UNITED STATES PATENT AND TRADEMARK OFFICE

Office Action Summary

10/648,876

REINEKE, FRANK

FIG. 4

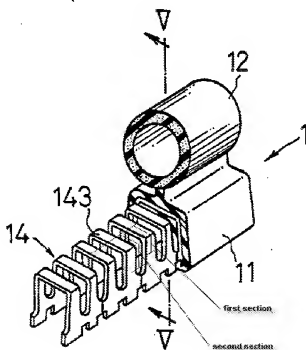
Regarding the applicant's comments concerning Shigeki et al., the examiner respectfully disagrees. As illustrated below, the claim limitation "sections" can mean

any part of the core member 14 and its extruded covering. Thus, the "sections" are discontinuous and can vary in length depending upon how one chooses to define a "section". The applicant's comments concerning Shigeki et al. failing to disclose two different materials whereby one material is continuously interrupted by pieces of the other material are not persuasive because they are not supported by the claim language.
